**Addendum / Addenda**

No./N<sup>o</sup>  
1

Project Description / Description de projet  Shipping and Receiving Remodel		
Solicitation No./ No de sollicitation  17-22118	Project No./N <sup>o</sup> de projet  STJ-5442	W.O. No./N <sup>o</sup> d'ordre de travail
Project Engineer / Ingénieur de projet  Rod Griffiths		Date  January 12, 2018
<p><b>Notice:</b> This addendum shall form part of the tender documents and all conditions shall apply and be read in conjunction with the original plans and specifications.</p>		<p><b>Nota:</b> Cet addenda fait partie intégrale des dossiers d'appel d'offres; toutes les conditions énoncées doivent être lues et appliquées en conjonction avec les plans et les devis originaux.</p>

**NRC Shipping and Receiving Renovations**

drawing no. 5442-A03 no. du dessin

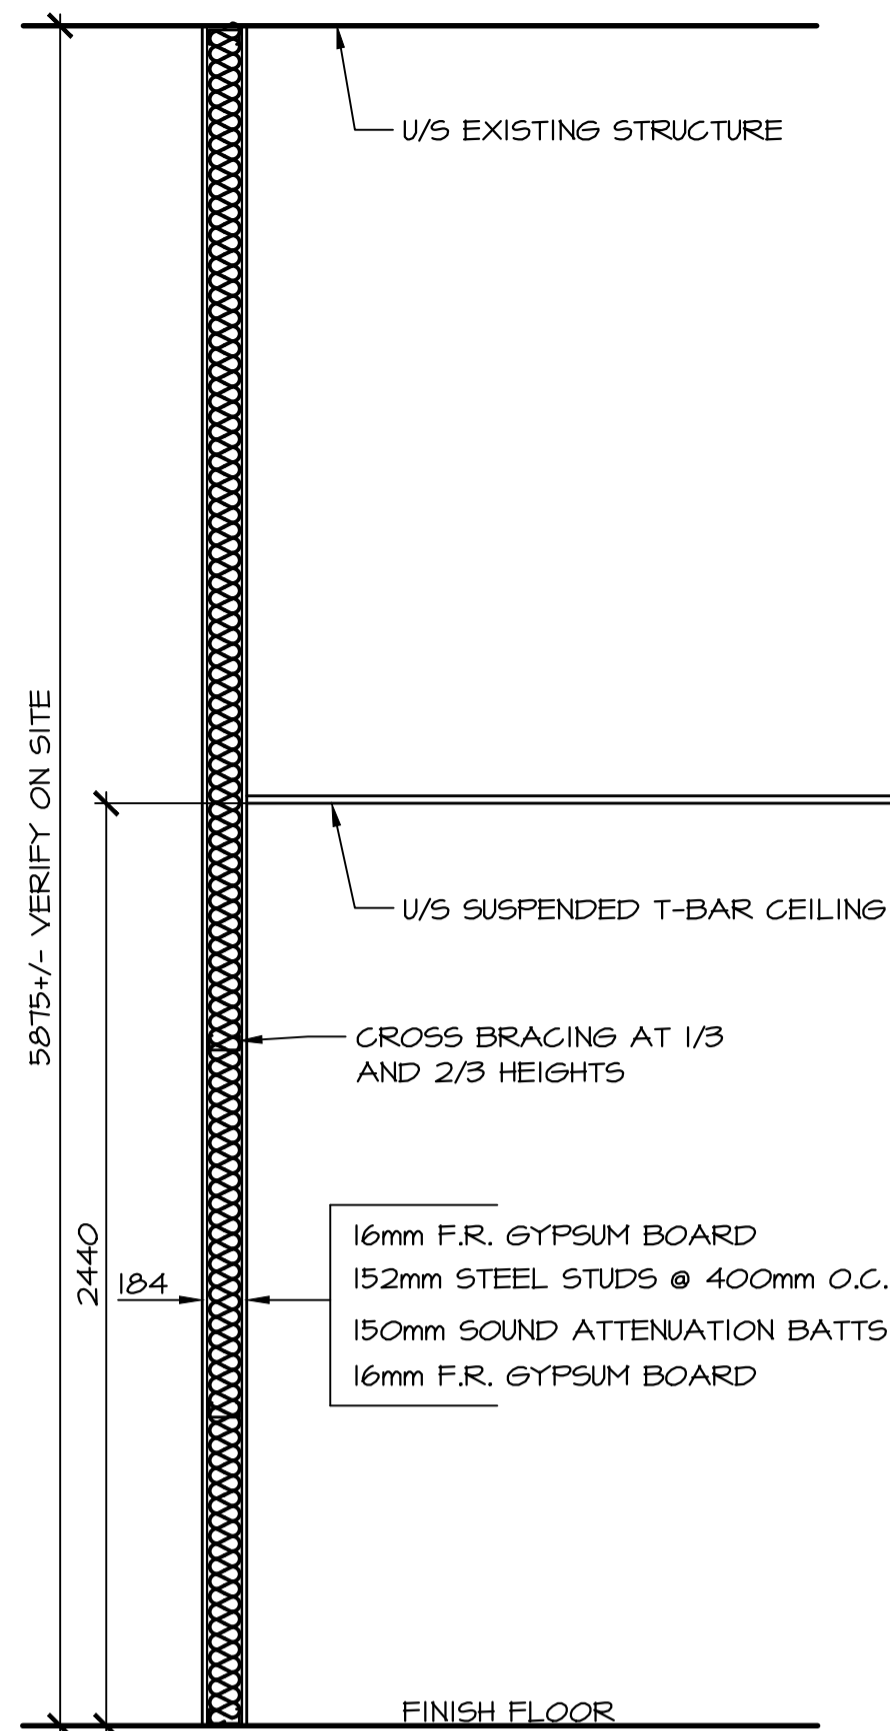
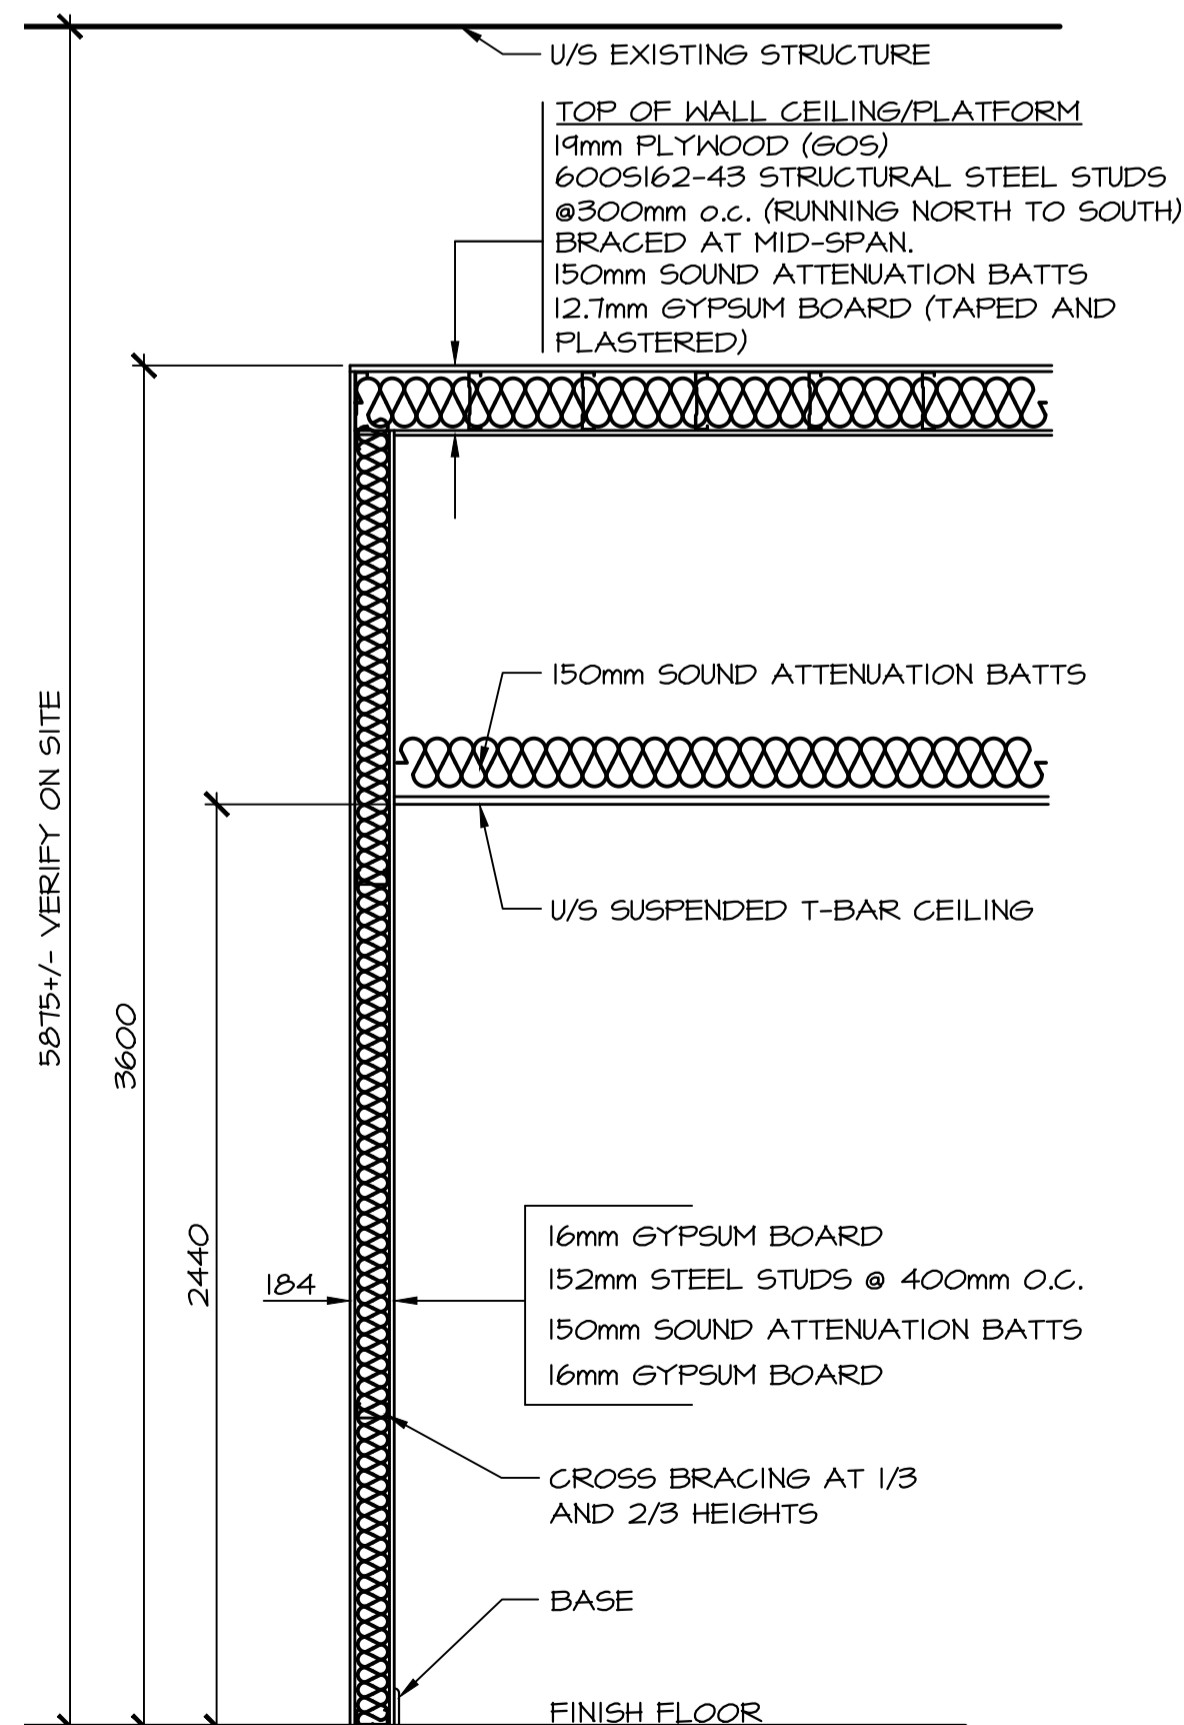
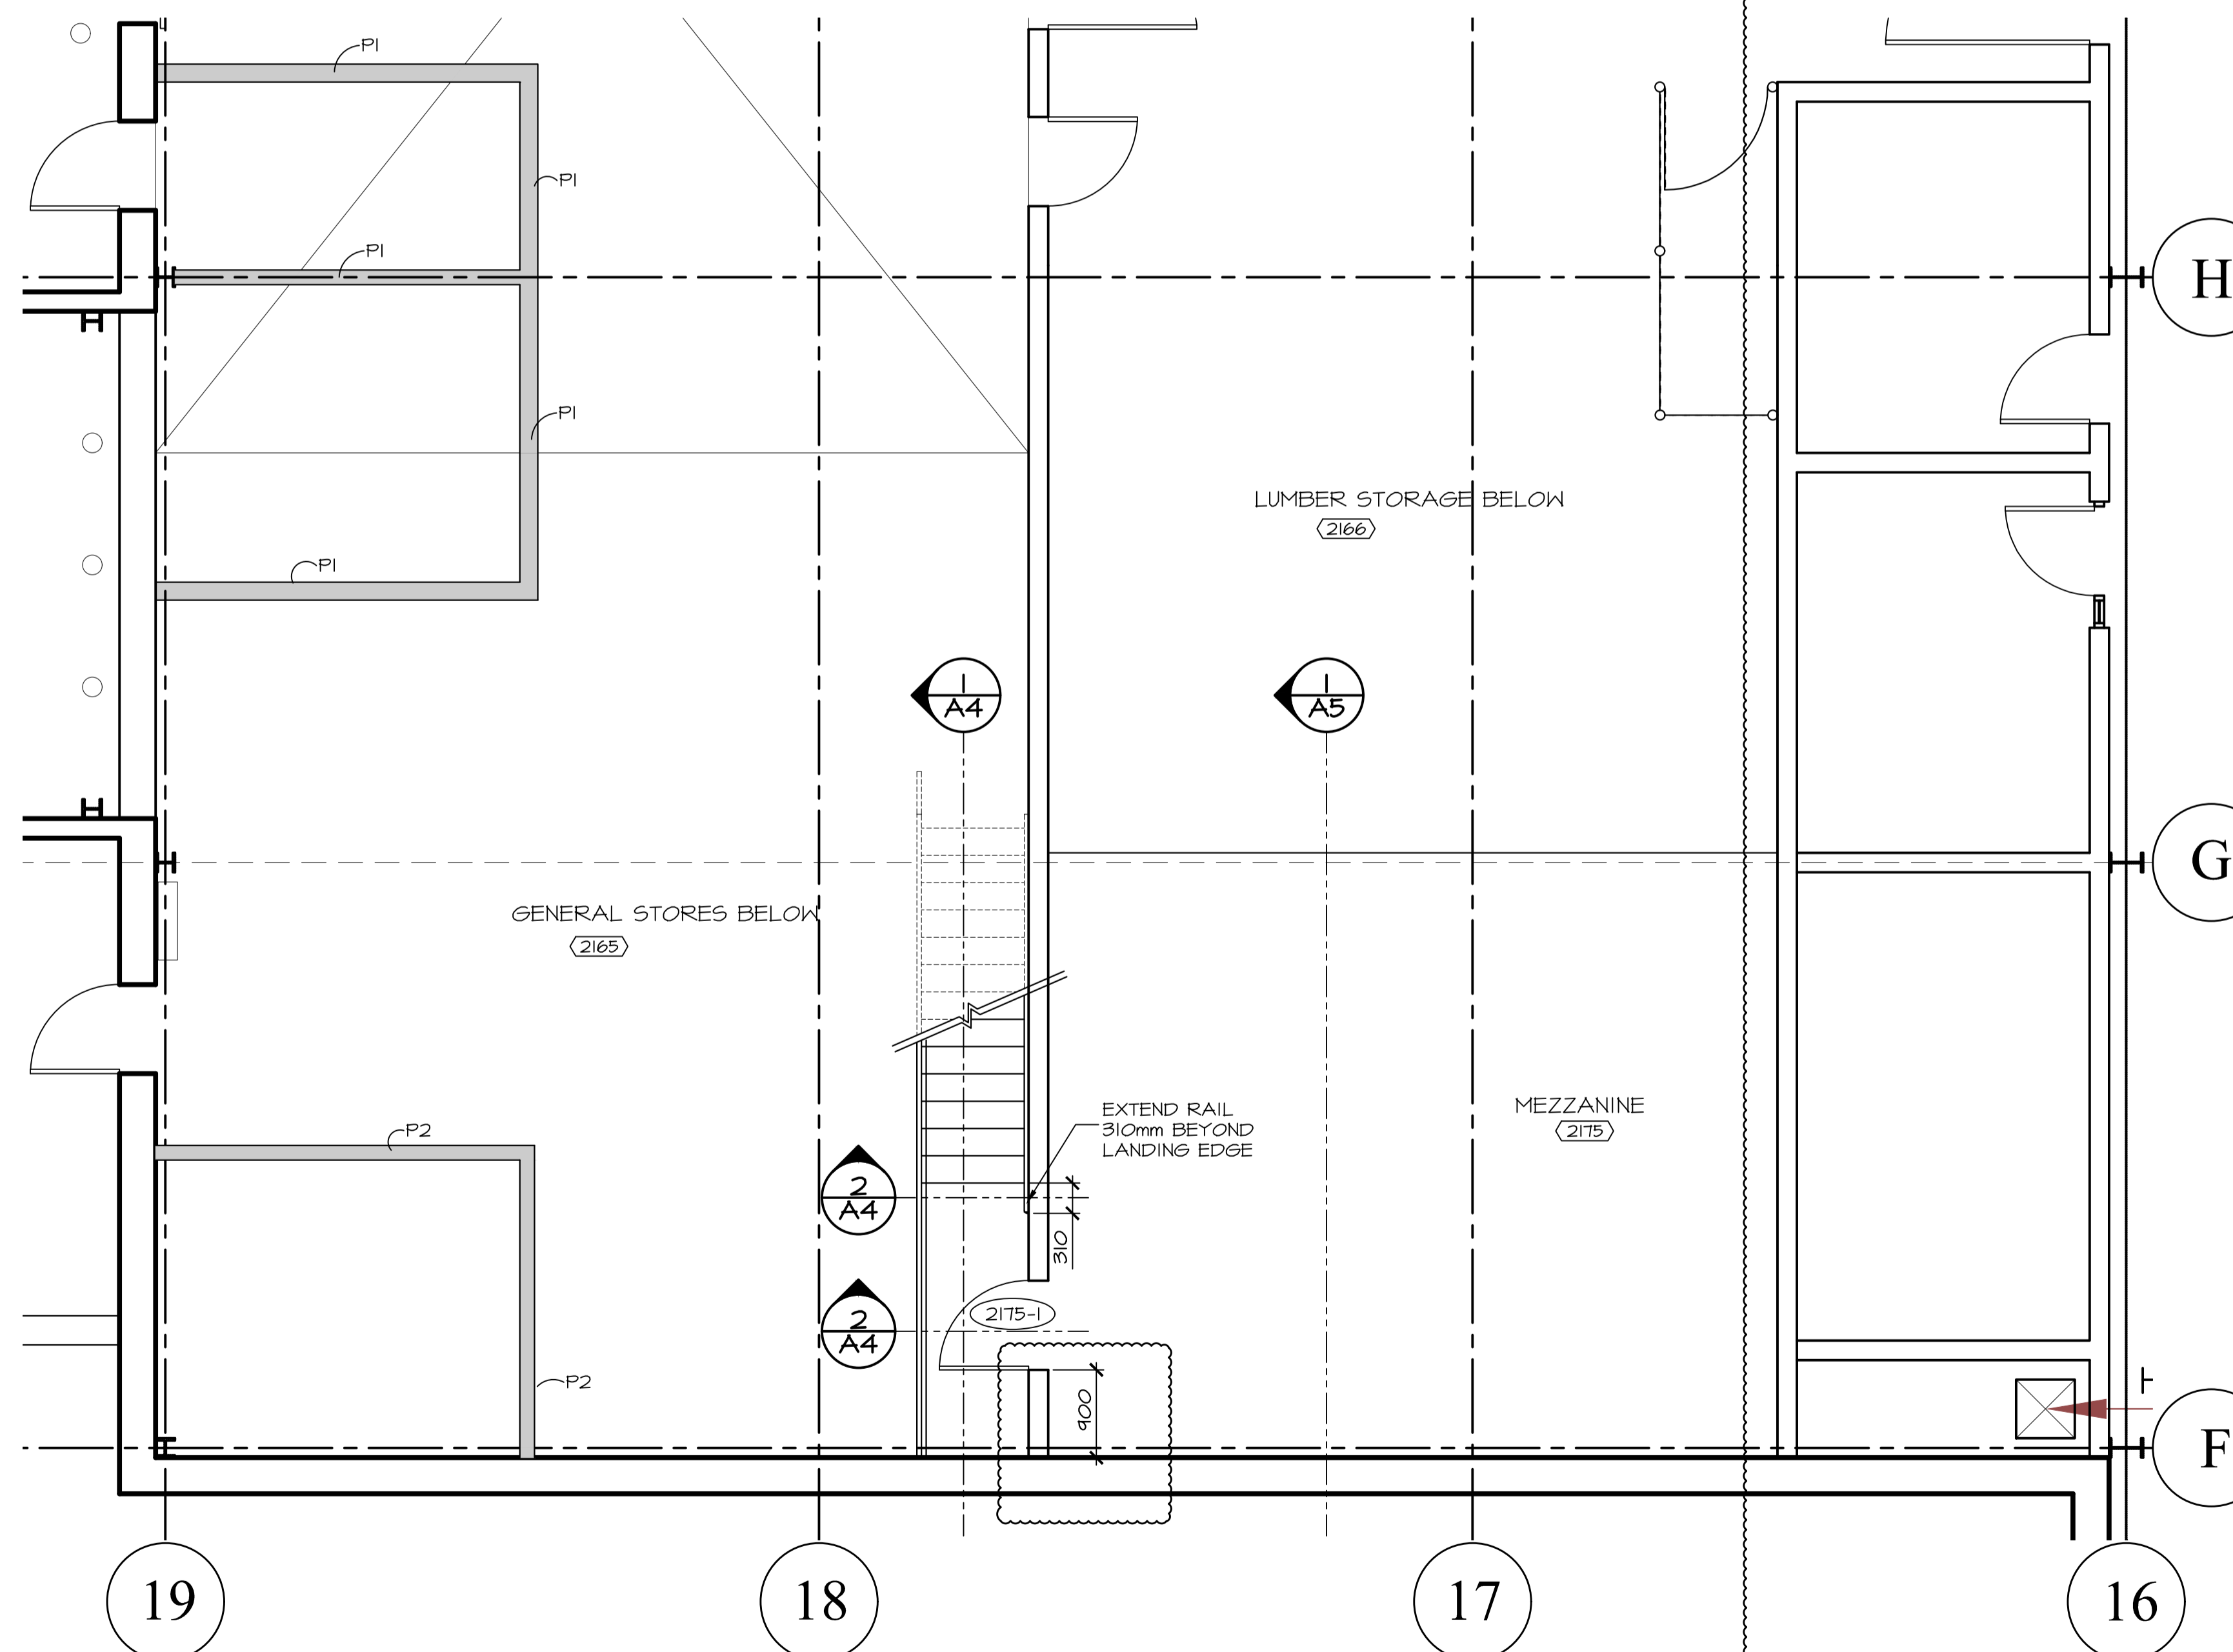
- .3 Refer: Drawing 5442-A03  
Grid Labels shown  
Full mezzanine plan shown.  
Dimension of new door from existing wall shown.  
Partition Type 1  
Construction of Partition type one changed to reflect full height of wall and the addition of the ceiling in the battery storage.  
Partition Type 2  
Construction of Partition type two changed to reflect height of walls and the addition of a ceiling/platform above the partition.  
See attached Re-Issued Drawing 5442-A03

NOTE: TOP OF WALL CEILING/PLATFORM FULL AREA OF NEW OFFICE #2173 AND NEW VESTIBULE #2176.

### SHUTTER PLAN DETAIL

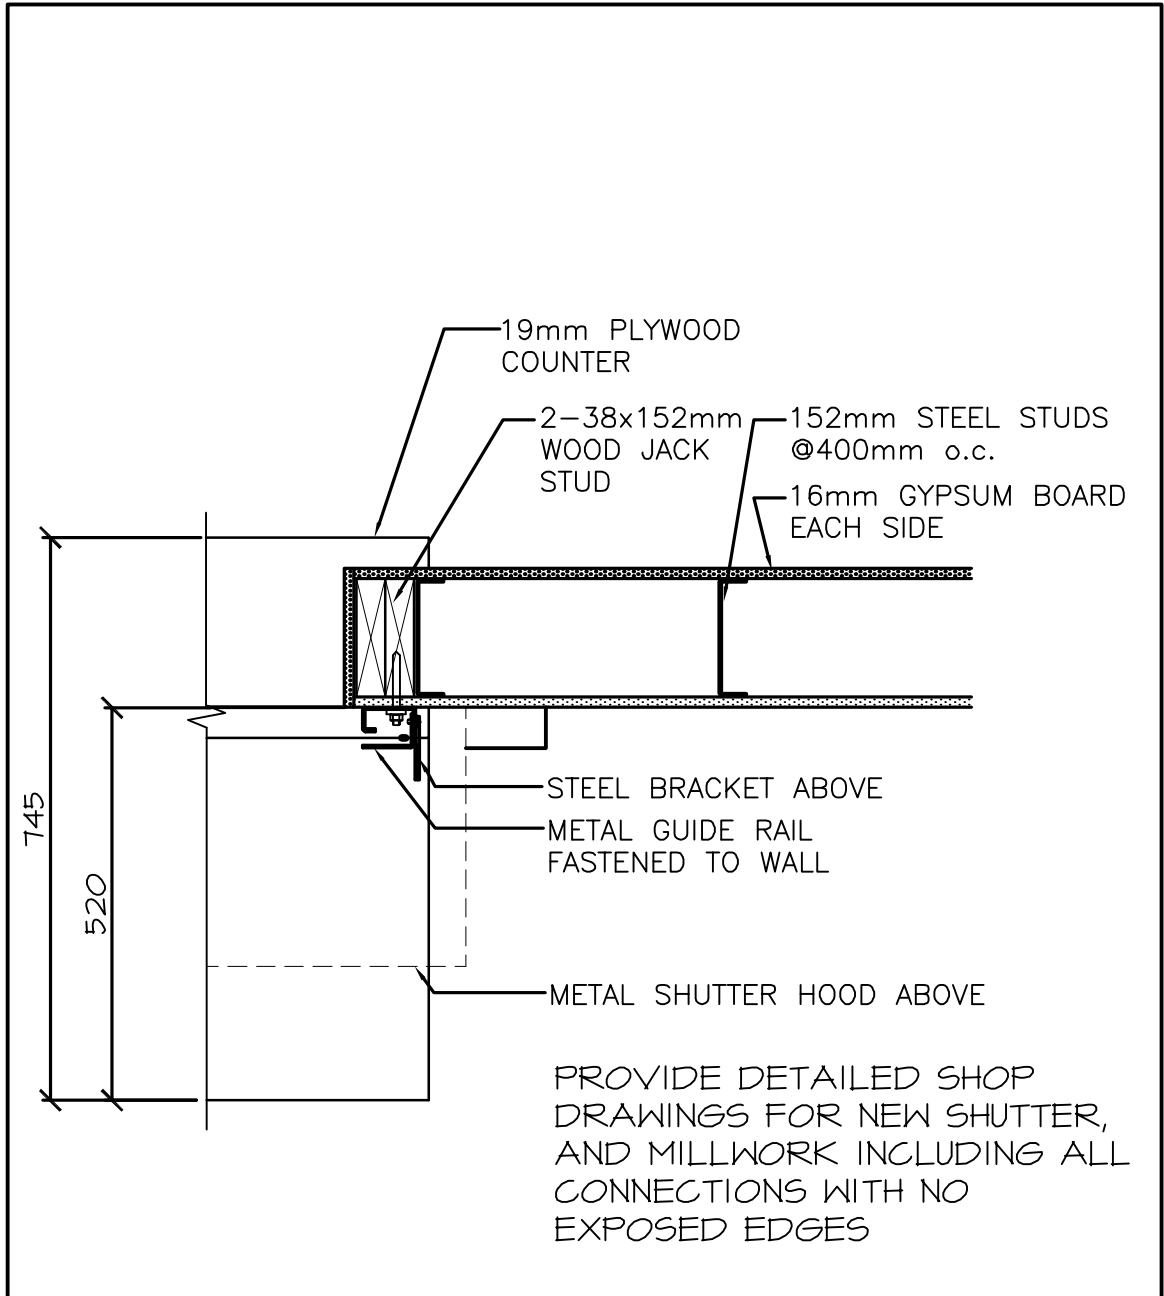
- .4 Refer: Drawing 5442-A05  
Reference Detail 3/A05  
Detail revised to reflect counter top and dimensions. See attached ASK 01  
Reference Detail 4/A05  
Detail revised at base, notes and dimensions added. See attached ASK 02

DETAIL REVISED TO REFLECT  
ACCURATE COUNTER TOP AND  
DIMENSIONS

VERIFY AND COORDINATE EXACT DIMENSIONS OF STORAGE CABINET TO BE RELOCATED WITH CLEARANCE SIZE UNDERNEATH COUNTER TOP. REFLECT SUCH IN SHOP DRAWINGS.

PROVIDE DETAILED SHOP DRAWINGS FOR NEW SHUTTER AND MILLWORK INCLUDING ALL CONNECTIONS WITH NO EXPOSED EDGES.

16ga STAINLESS STEEL TOP WRAPPED EDGES WITH NO EXPOSED EDGES.

## SHUTTER SECTION DETAIL

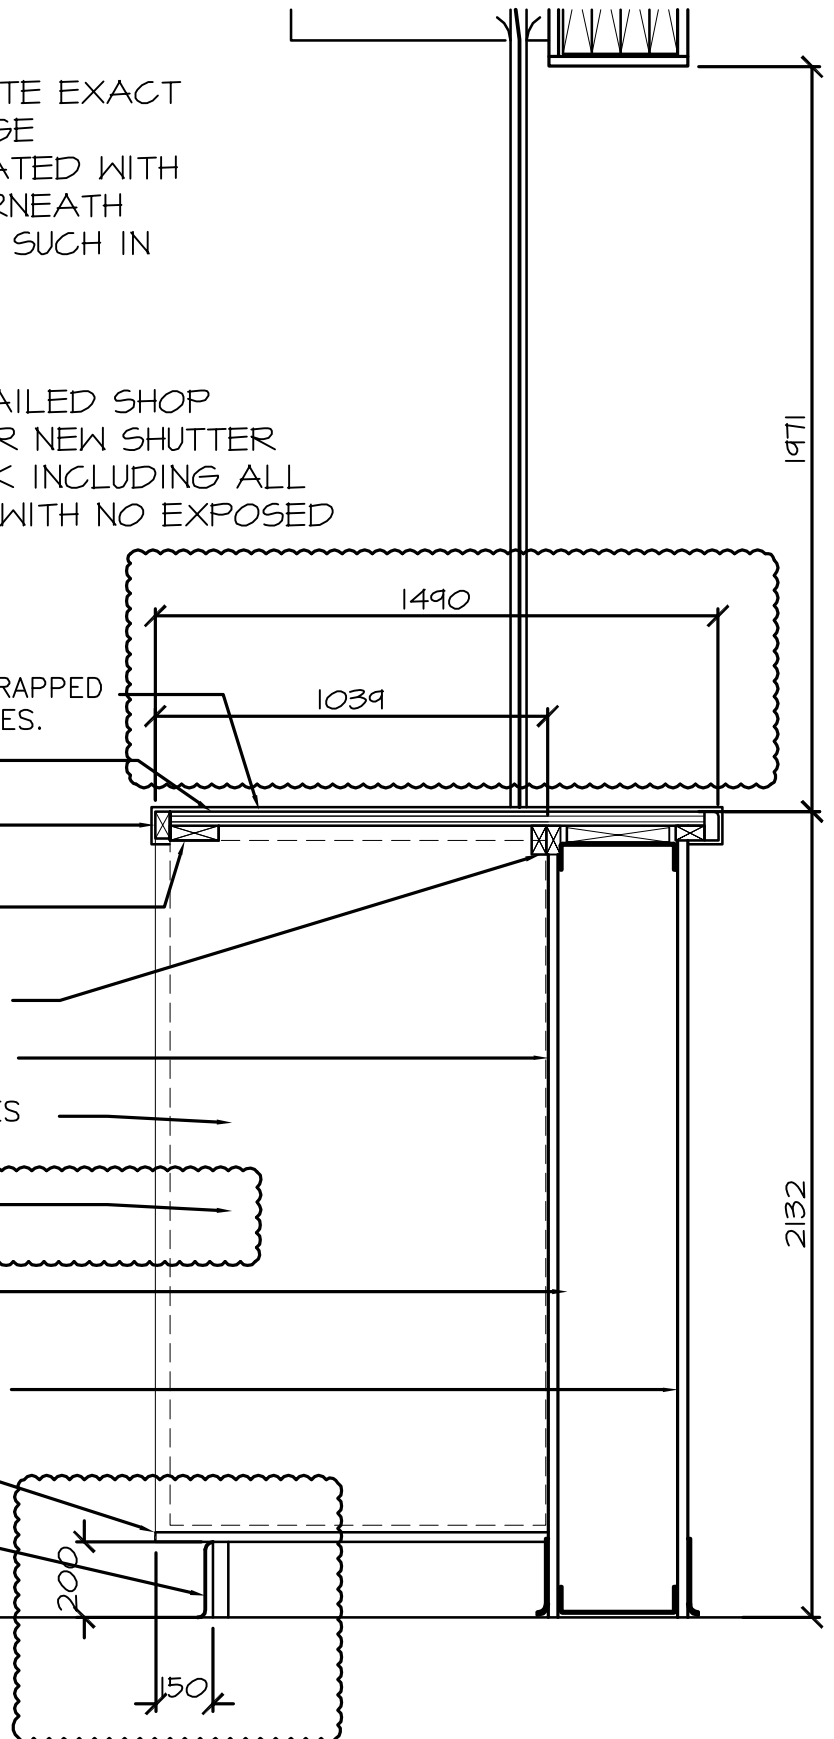
# PARTIAL DETAIL SHOWN TO NOTE CHANGES TO DETAIL AND INCLUSION OF DIMENSIONS.

RELOCATED STORAGE UNIT. COORDINATE WITH OWNER.
